BID/ RFP ADDENDUM No.2
DATE: 08/16/2023
BID/RFP No: 2022-19
BID NAME: Vocational Building Remodel

ADDENDUM NO. 02

CAREER TECHNICAL EDUCATION BUILDING RENOVATION
Merced, CA

The following additions, deletions, and revisions to the SHEETS and Project Manual are hereby made and do become a part of these Contract Documents.

CONSTRUCITON STAGING AREA PLAN

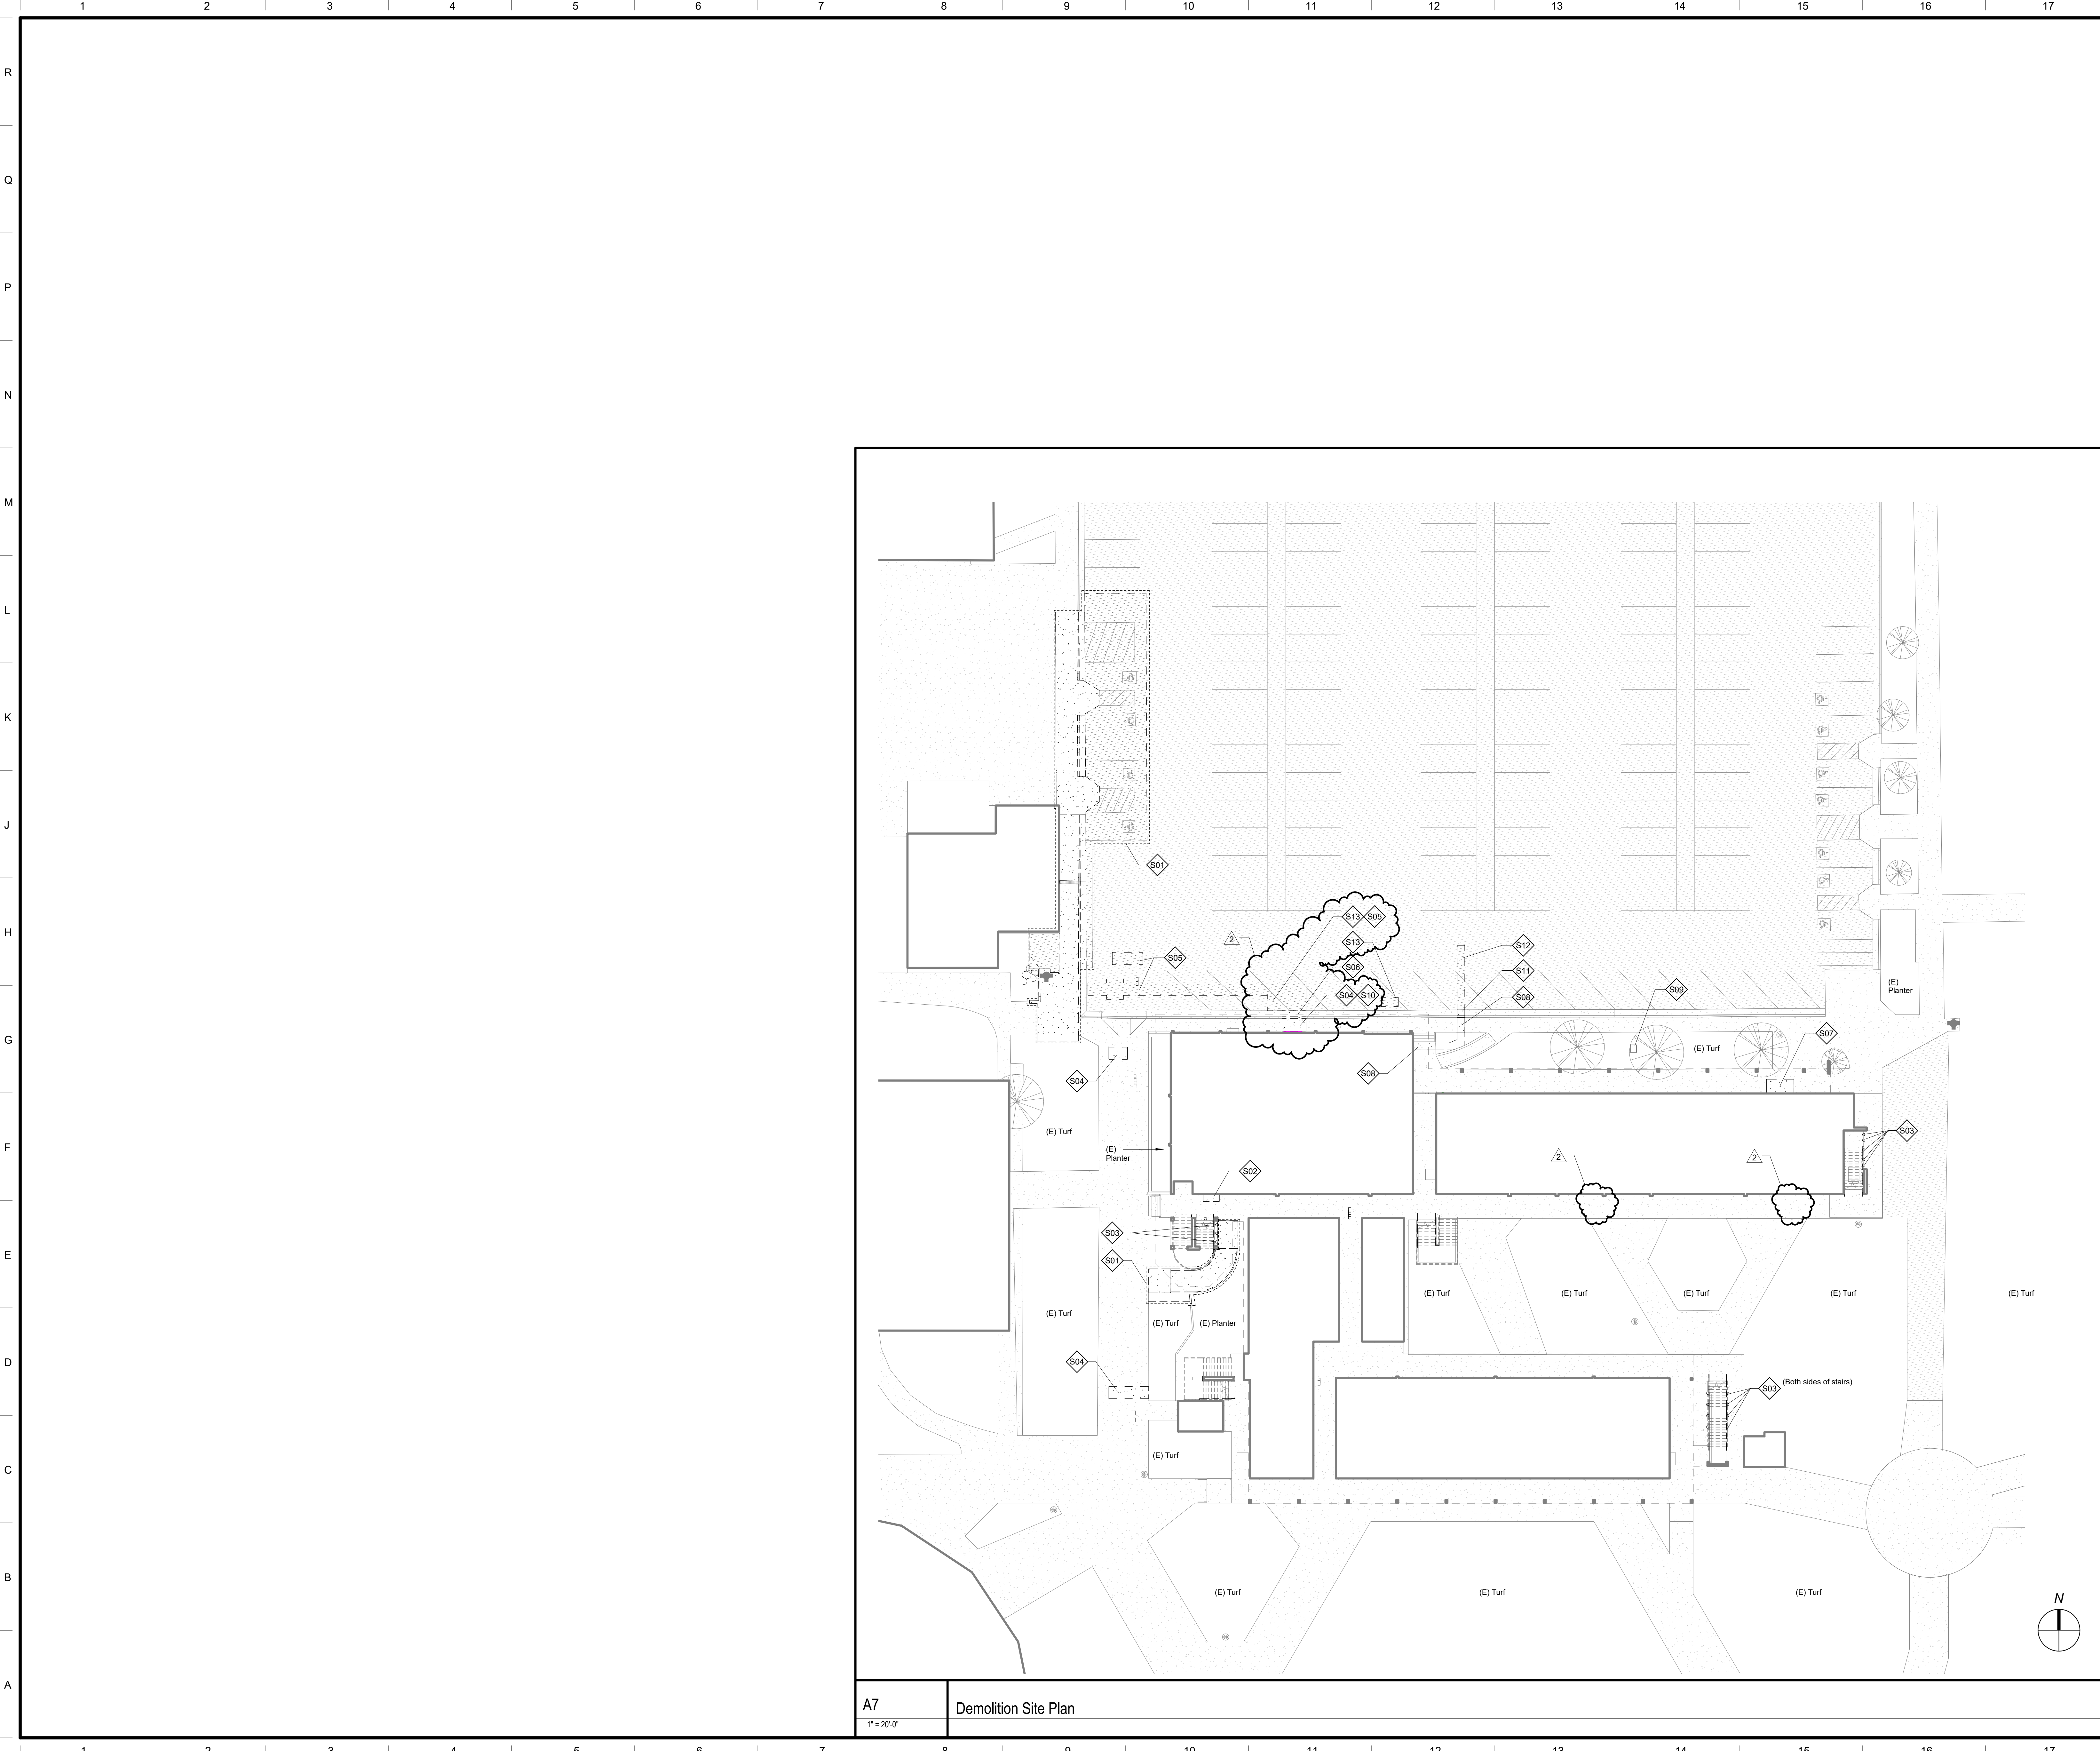
1. As an appendix to the section, insert attached drawing sheet SA-01 CONSTRUCTION SITE ACCESS PLAN with AD2 in the upper -hand corner.
- a. Appendix drawing indicates the Owner's requirements for contractor site staging, parking, and Owner access around the site during Construction. Requirements included are in addition to those stated within the TEMPORARY FACILITIES AND CONTROLS SPECIFICATIONS SECTION.

SITE DEVELOPMENT
DEMOLITION SITE PLAN

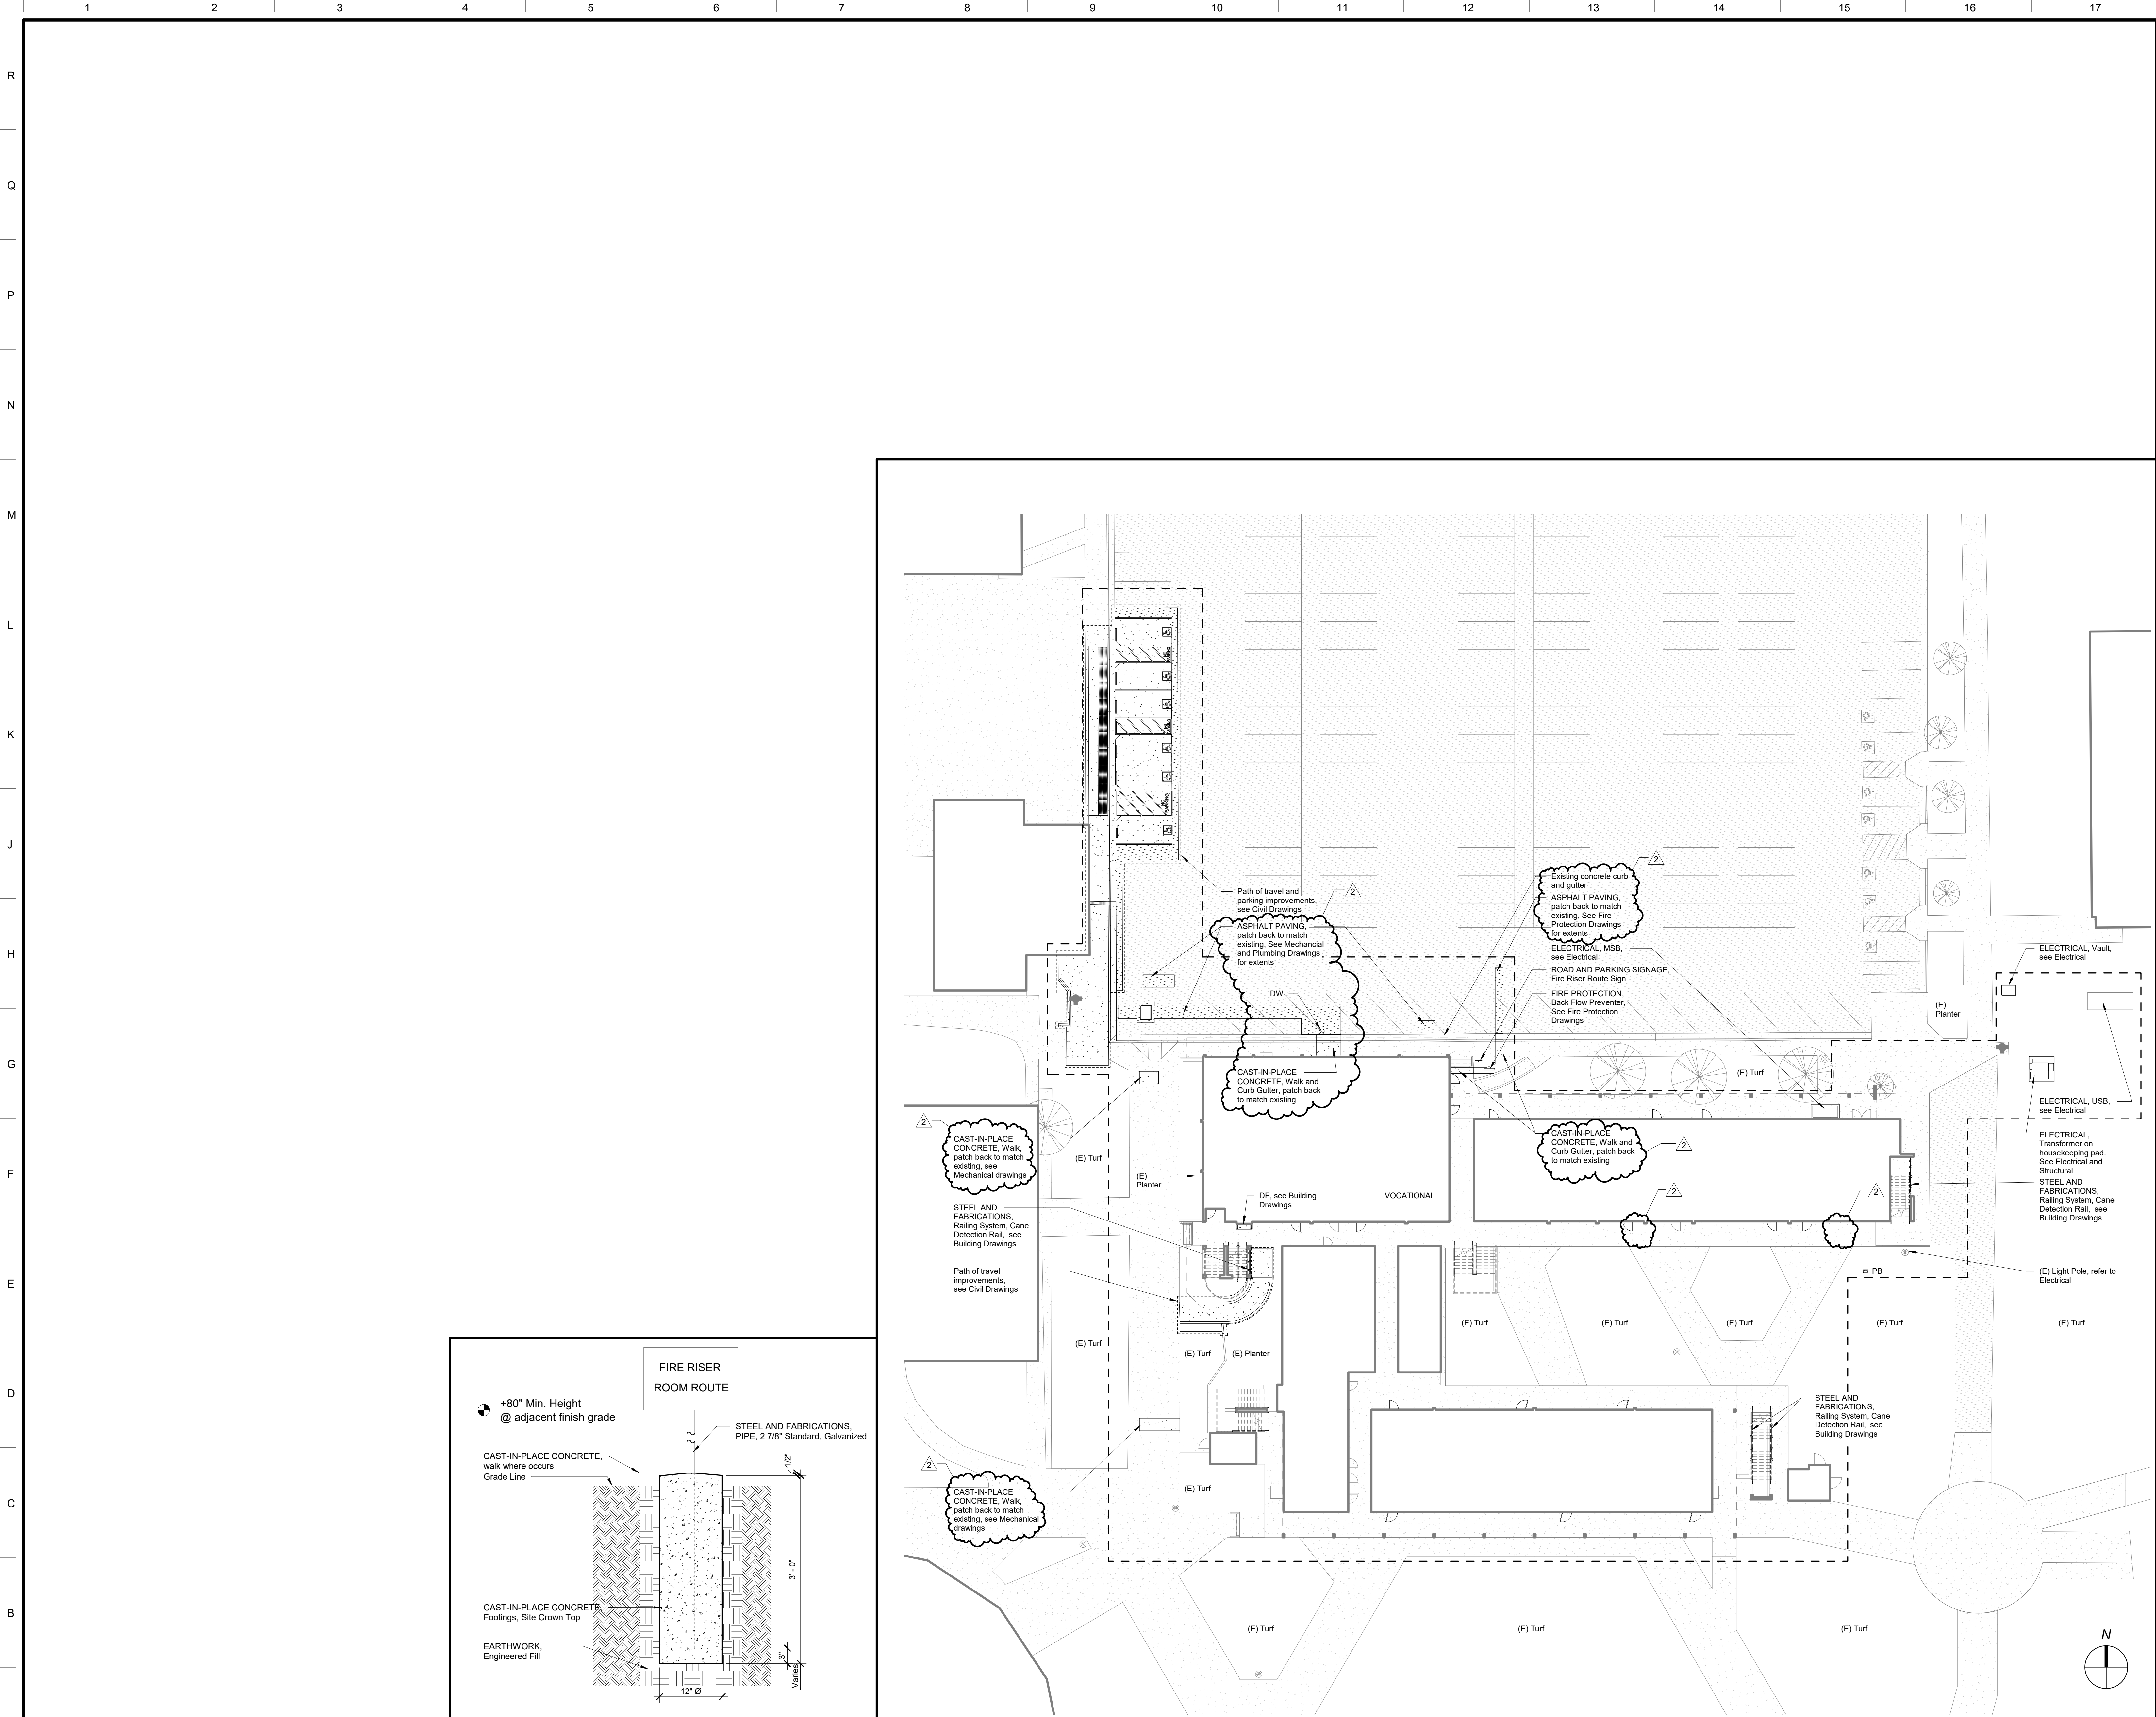
AD2-A01 Refer to Sheet SD/A101, DEMOLITION SITE PLAN:

1. Replace sheet with attached sheet SD/A101, DEMOLITION SITE PLAN with AD2-AX01 in the lower right corner. Changes are in the clouded area(s).

SD/A102

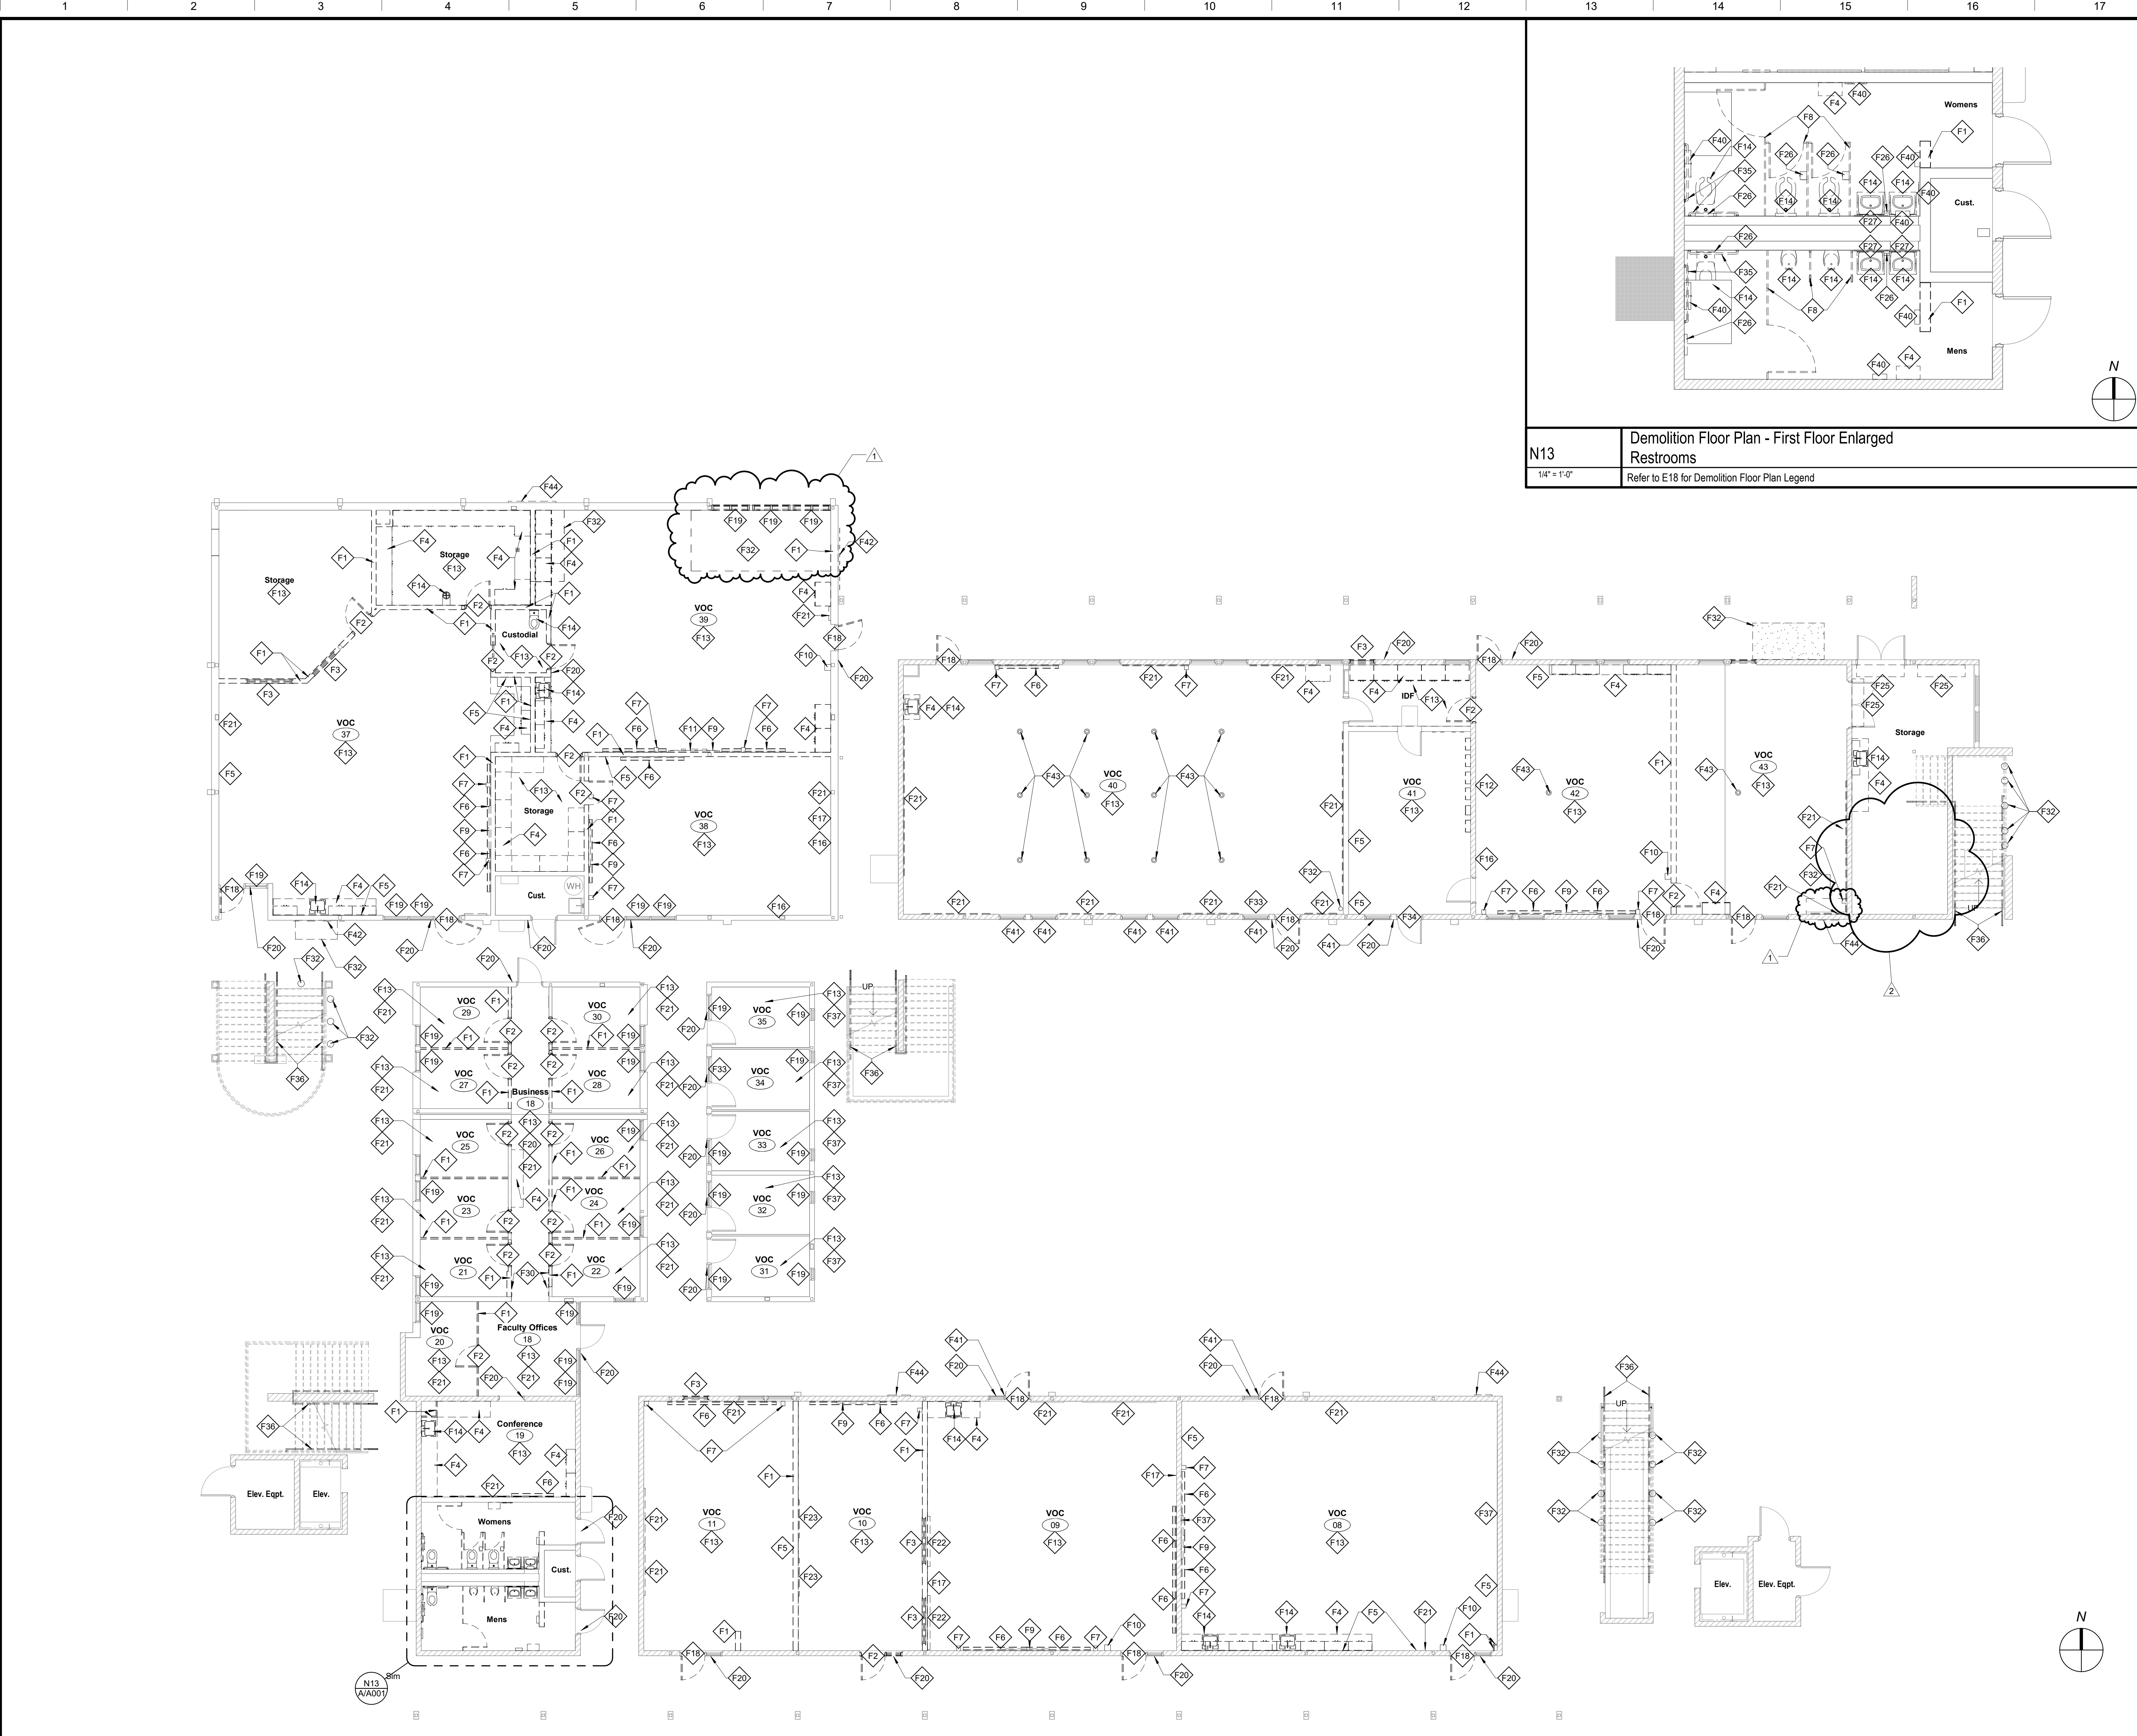
AD2-A02 Refer to Sheet SD/A102, SITE PLAN:

1. Replace sheet with attached sheet SD/A102, SITE PLAN with AD2-AX02 in the lower right corner. Changes are in the clouded area(s).
